ADDENDUM NO. 1

To the Contract Documents for
Greenway Meeting Place Project
For
The Borough of Chambersburg, PA

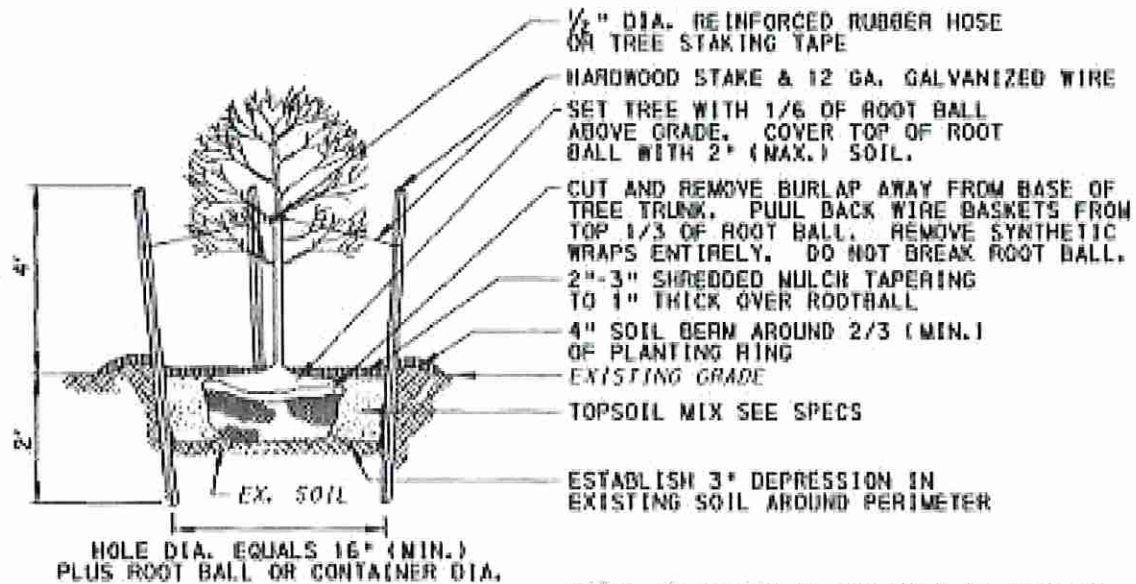
Q: Can a cross-section detail of the tree pit be provided? Confirm this is just an excavation and not a concrete tree vault style pit with weep holes.

A: Excavation only (see detail provided)

NOTE: IF BOTTOM OF THE HOLE IS ROCK OR HARD CLAY, BREAK UP AN ADDITIONAL 6" DEPTH TO ALLOW WATER TO DRAIN
